# 7903 GREENWOOD AVE N

EARLY DESIGN GUIDANCE RESPONSES

ADMINISTRATIVE DESIGN REVIEW  
MAY 29, 2020 #3032858-LU

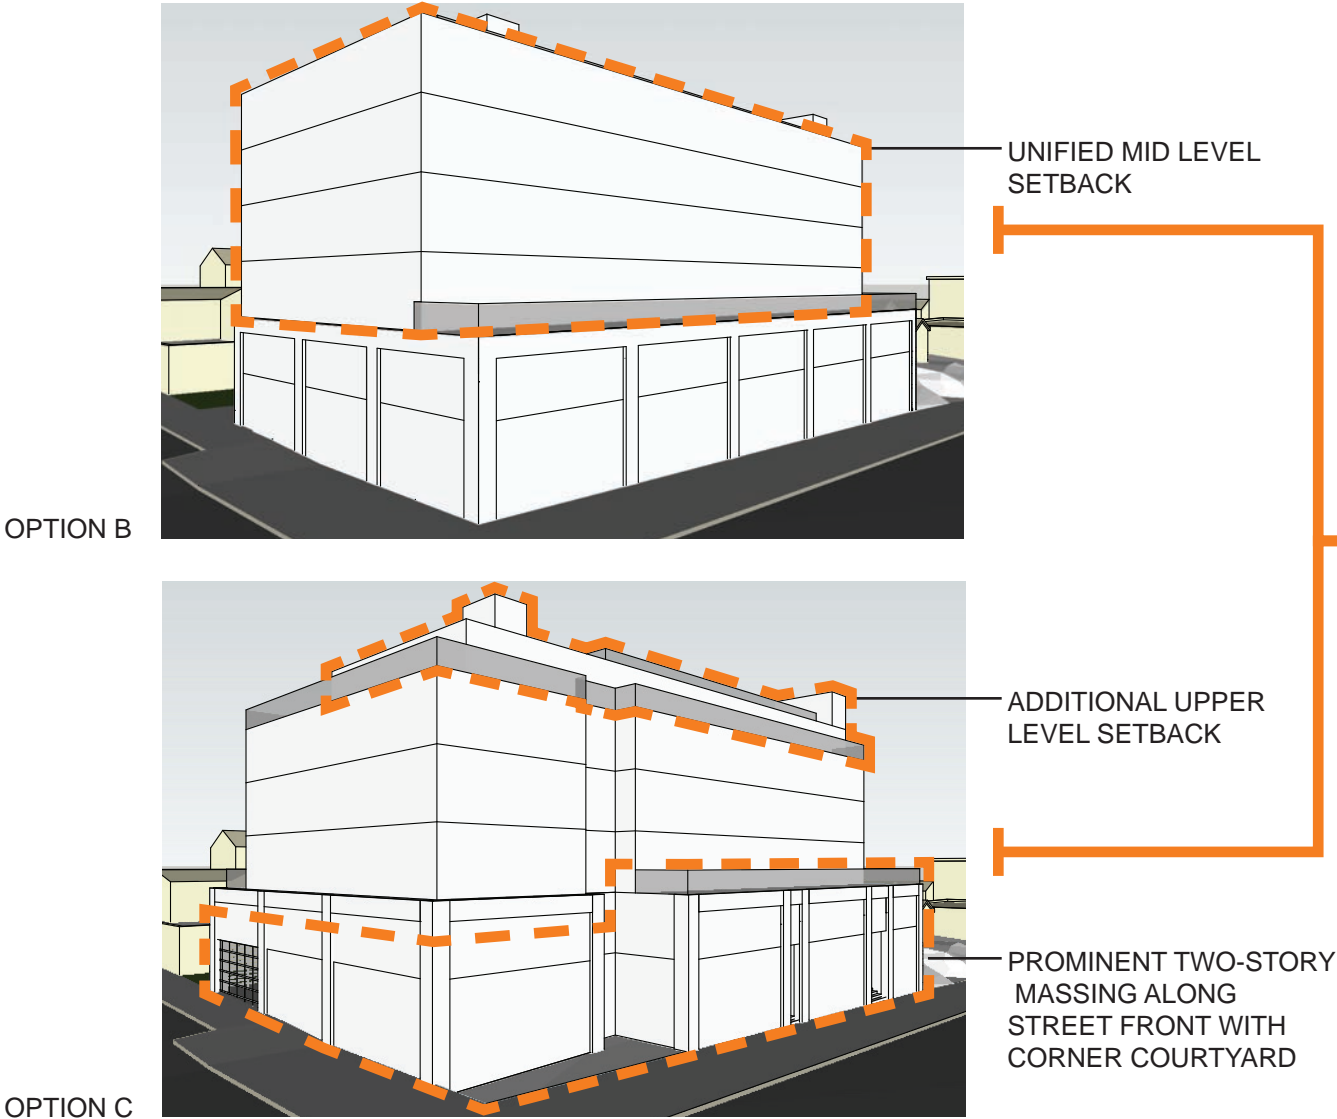
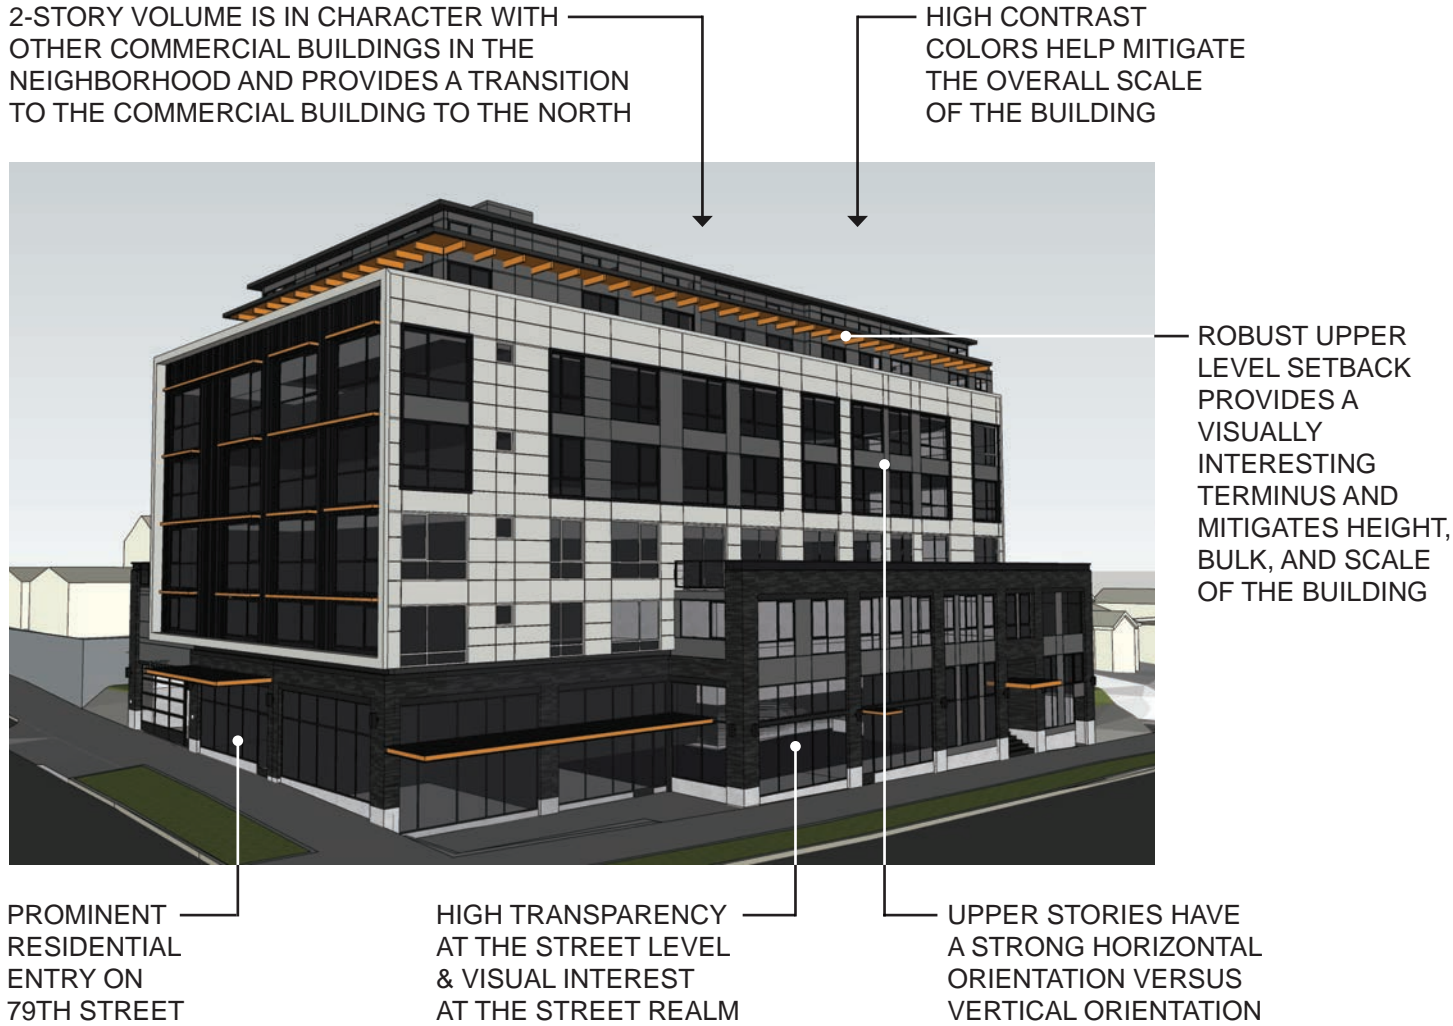
- 1) Massing
- a. The Board discussed the merits of the three massing options, supporting elements of Option B and C. Ultimately, the Board recommended further development of the preferred option, C, with the introduction of particular qualities of Option B.

- b. Those qualities of Option B the Board supported included: the strong two-story base expression and implied commercial storefront rhythm of the base. The Board agreed that the strong base with consistent rhythm at the street was an appropriate response to the existing neighborhood context. The Board recommended the project include this two-story base expression with bay rhythm. Careful integration of the townhouse entries will be important to the success of the rhythm. (CS3-II Compatibility, PL2-A Entries)

- c. The qualities of Option C most supported by the Board included the upper level setbacks and corner plaza at the ground level. The Board agreed the upper level setbacks provided an appropriate transition to the single-family zoning and existing school to the west and mitigated any possible blank wall conditions, and the corner plaza would offer a useable space for the neighborhood and provide opportunities to foster human interaction (CS2-D Height, Bulk, and Scale, PL1-A-2 Adding to Public Life, DC1-I Blank Walls).

- d. Option C included a vertical notch extending from the top down to the ground. The Board expressed concern that this notch implied a primary residential entry and diminished the strength of a two-story base. To maintain the strength of the two-story base expression, the Board recommended eliminating the vertical notch from the base. (CS3-II Compatibility)

a. - b. The proposed design represents an evolution of Option C presented at the early design guidance meeting, with qualities of Option B incorporated, per the board's guidance. The building's east façade on Greenwood Ave. N. includes a strong two-story base expression at the street level responding to the existing context and recognizing the historical patterning of the neighborhood. The two-story base is articulated with the bay proportions, materials, and commercial storefront rhythm found elsewhere in the neighborhood. The two-story base on Greenwood Ave. N. transitions to one-story expression as it wraps the corner of N. 79th st., responding to the pedestrian scale of the main residential entry and a more appropriate scale for the residential street and character. The two townhouse entries are located to the north and collected within a single bay integrating it within the two-story base. The residential entry scale and proportions are expressed with a change of bay proportion, material expression, raised entry, setback off the sidewalk, and deep canopy.

c. - d. The proposed design reflects the board supported qualities of Option C with upper level setbacks at levels 3 and 6 eroding the building mass adjacent to the single-family zoning and the school to the west, reducing the structure's perceived height, bulk, and scale. The south east corner of the building is set back from the sidewalk, creating an entry plaza that provides relief and light to the corner, offering usable space, engaging the public space and encouraging pedestrian interaction. The vertical notch initially located at the south east corner of the building and expressed from level six down to grade has been removed, per the board's guidance.

VEHICULAR - PEDESTRIAN INTERACTION

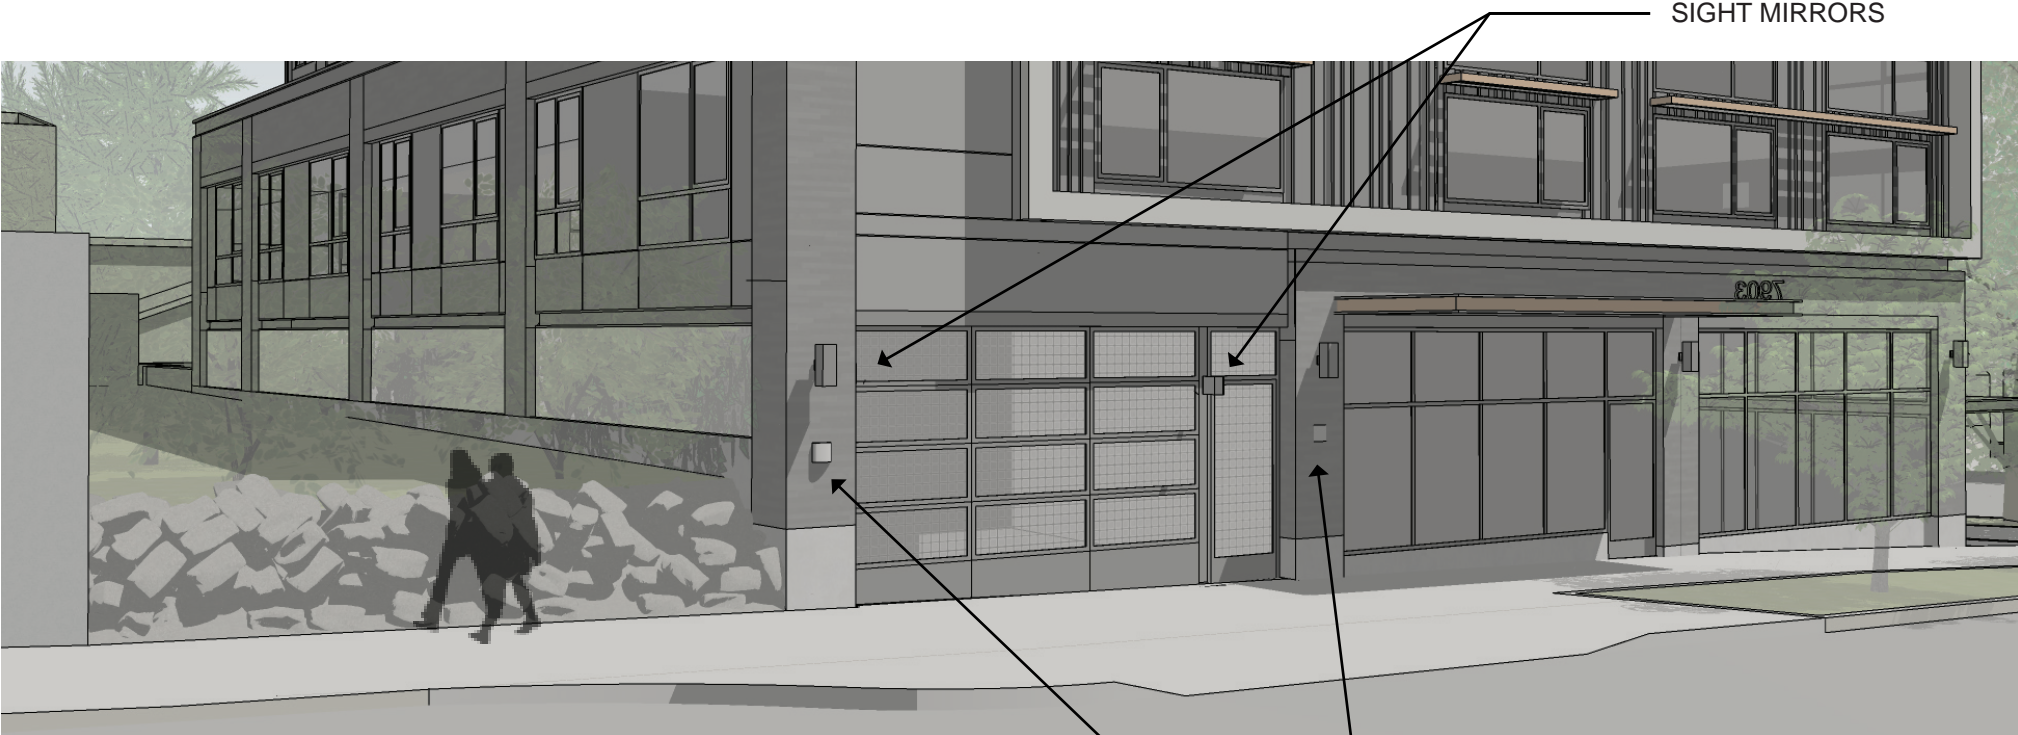
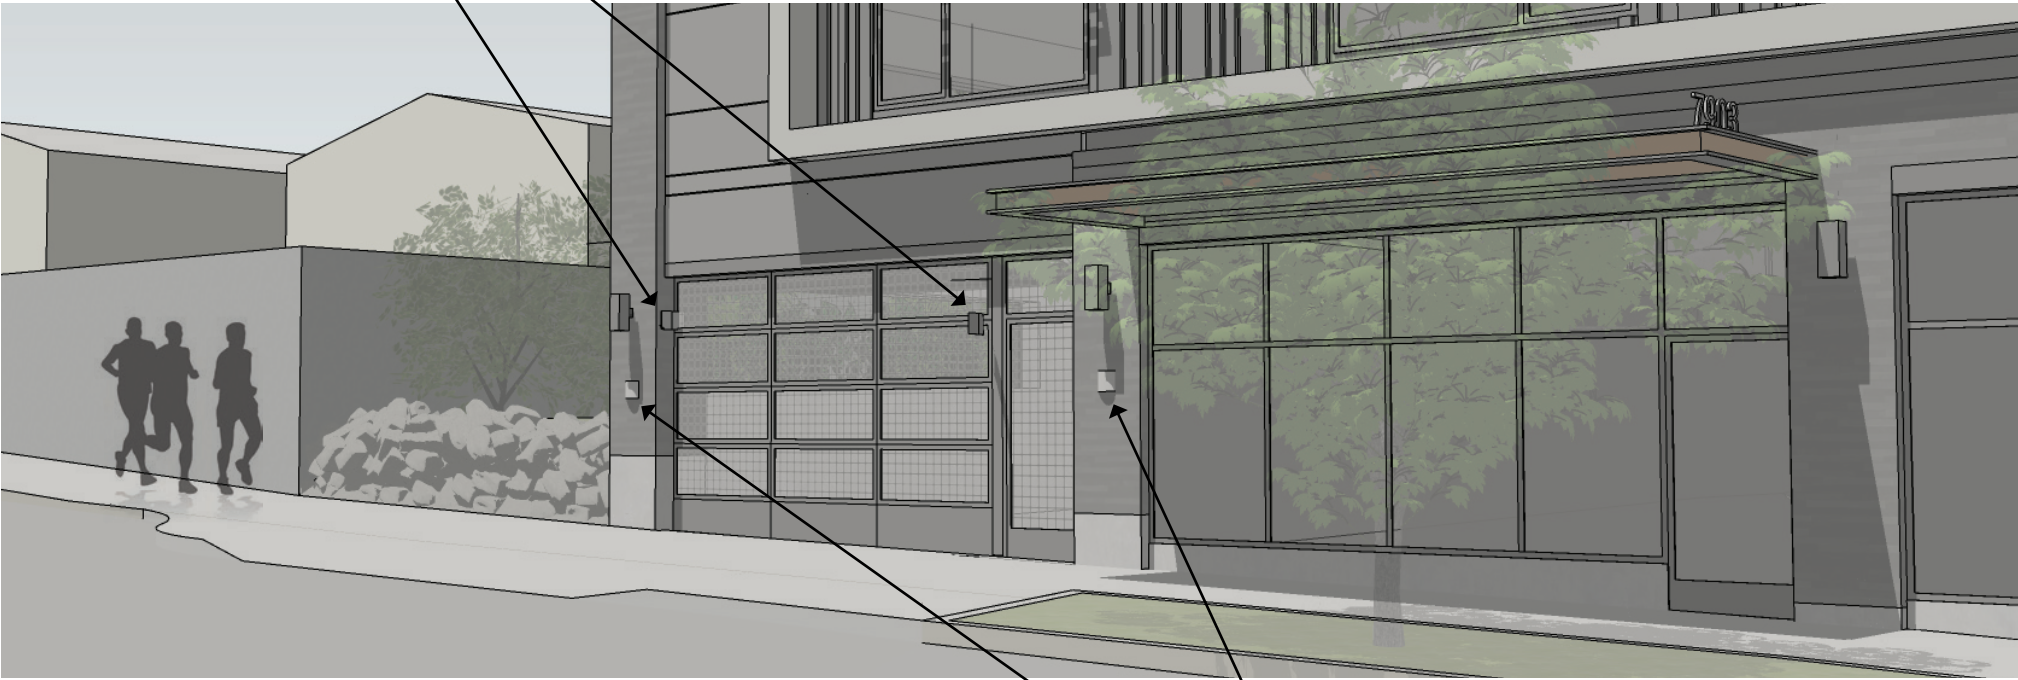
- 2) Ground Level: Vehicular-Pedestrian Interaction:
- a. Public comment described a high level of pedestrian traffic, particularly children, from Greenwood Ave N past this site to the adjacent school. With the garage entry proposed on N 79th Street, concern with vehicular-pedestrian conflicts was expressed.

- b. The Board acknowledged this public concern and agreed the garage entry should be designed with safety in mind (PL1-B Walkways and Connections, PL2-B Safety and Security, DC1-B Vehicular Access and Circulation).

- c. The Board suggested techniques that could be used to mitigate conflicts such as eroding the mass or utilizing the 20-foot ground level setback for increased driver visibility (PL2-B Safety and Security, DC1-B Vehicular Access and Circulation).

- d. The Board requested studies demonstrating this garage entry sequence, including sight triangles and driver sight lines (PL2-B Safety and Security, DC1-B Vehicular Access and Circulation).

a. - c. The entrance to the single ADA van parking stall is located on N. 79th St. as directed by SDOT. The remainder of the outdoor area includes exterior bicycle storage, exterior garbage/recycling storage and the on-site staging area for the garbage/recycling containers. The ADA van parking stall is provided immediately at the entrance gate with back-in parking only to maximize pedestrian safety when entering and exiting the parking stall. Vehicular access traffic and frequency is significantly lessened with only (1) parking stall provided. Pedestrian safety is addressed by maintaining clear sight lines at the garage entry, maximizing driver and pedestrian visibility while entering and exiting. The open parking area design allows for natural light and transparency for additional visibility and safety. Sight Triangles are not required for the project, the sight triangles shown in the illustration study have narrower but reasonable sight lines. Automated vehicular warning lights and audio sound alert system is provided for pedestrian safety. Lower light and audio levels will be used, as N 79th St is a residential street.

d. A study illustrating the parking stall entry access for vehicular-pedestrian safety and driver sight lines is provided on this page.
